MEMORANDUM

SUBJECT: Consider Approval of Conifer Ridge Apartments, County Road D East, between Hazelwood Street North and Kennard Street

- A. Planned Unit Development Revision
- B. Public Easement Vacations
- C. Lot Division
- D. Design Review
- E. Development Agreement

WEST ELEVATION
 3/32" = 1'-0"

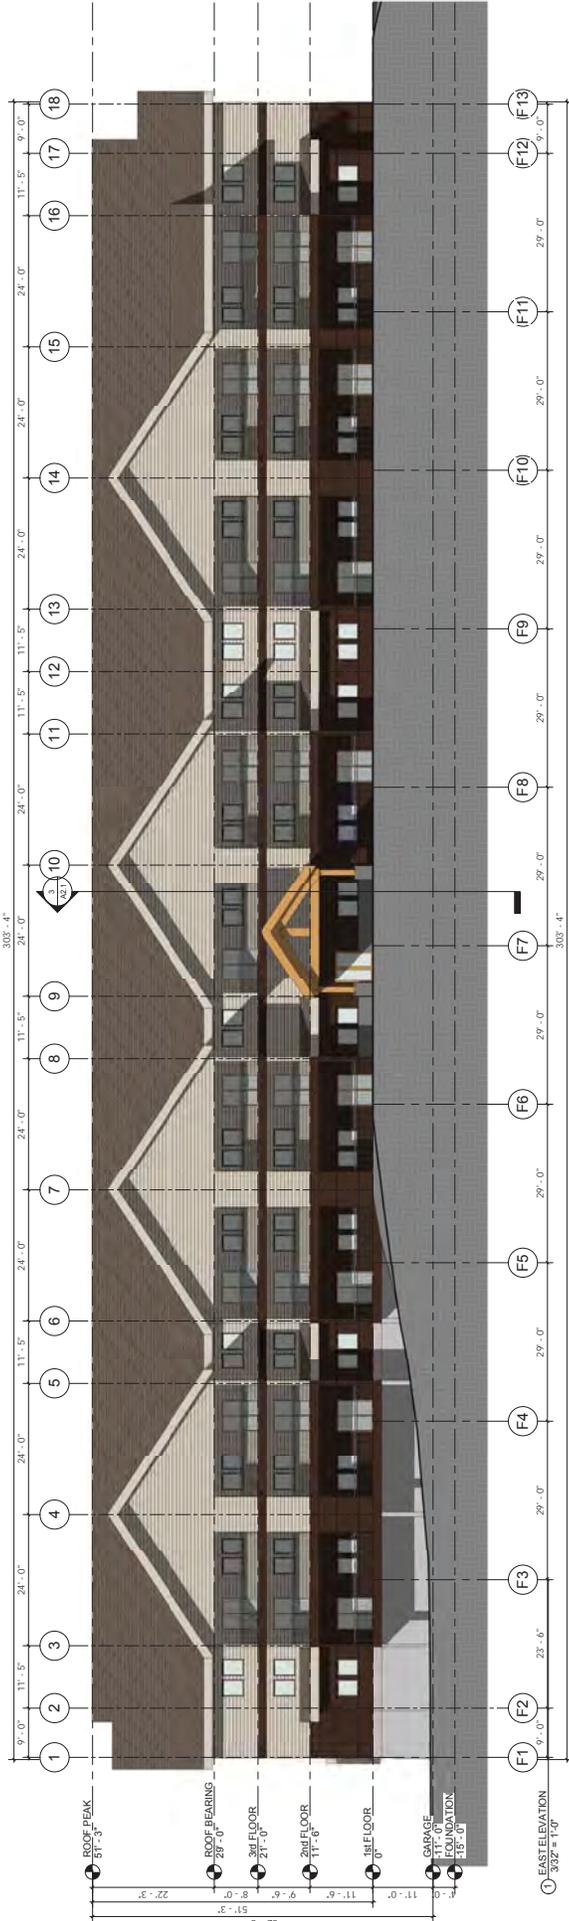
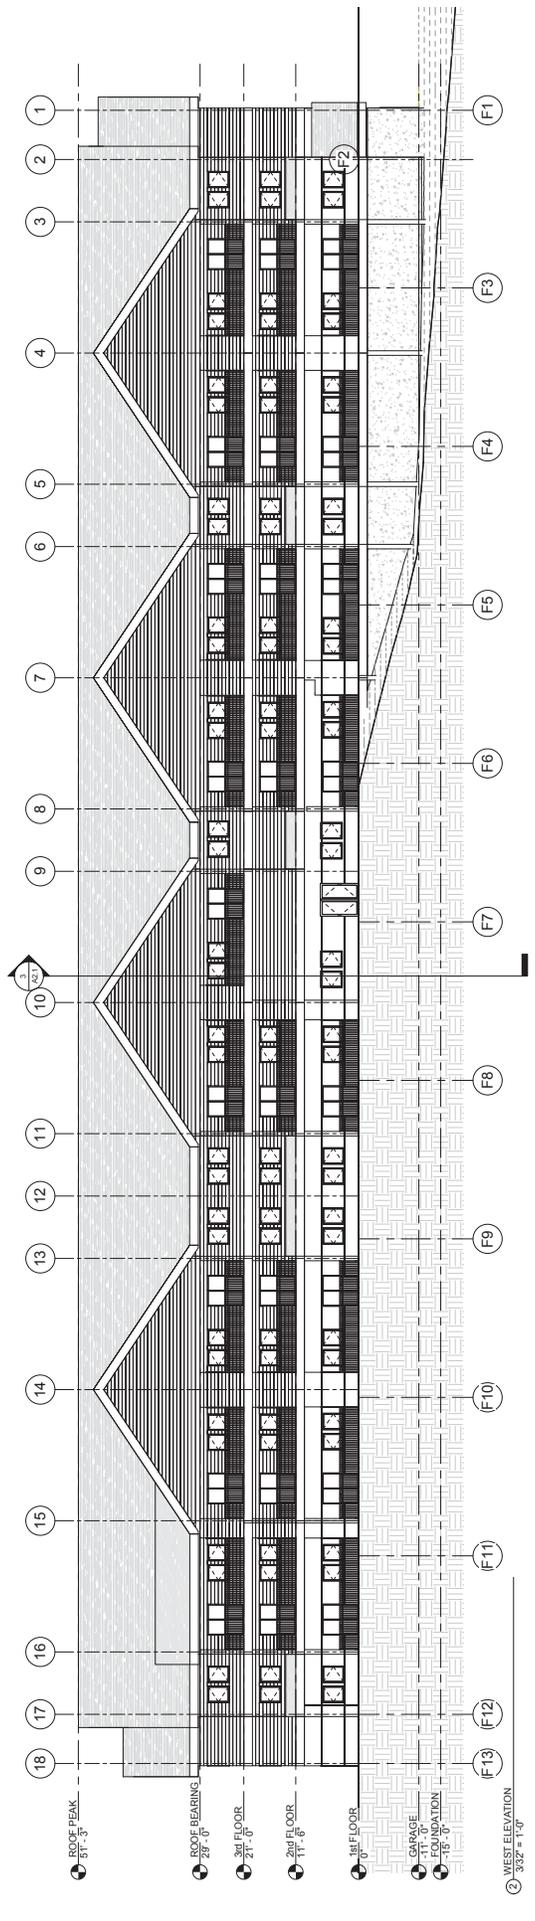
- The building elevations shall be revised to include brick or stone elements on the first or lowest level of each building. These elements shall be consistent with design standards found throughout Legacy Village. The gable areas of each building shall also be required to add architectural elements.

The proposed apartment buildings would be attractively designed but staff would like to see more effort put into matching some of the design elements found elsewhere in Legacy Village. The applicant's plans propose the use of cement board lap siding for the upper two floors and board and batten cement board for the lower floor. Staff would recommend the applicant add brick or stone into the elevations to match design elements found in the nearby townhomes. In addition, some type of architectural feature should be added to the gable areas on the buildings' third level.

- f. Provide revised building elevations for staff approval incorporating design elements at the foundation and first floor level of brick or stone into the buildings and adding architectural features to the gable areas of the buildings.
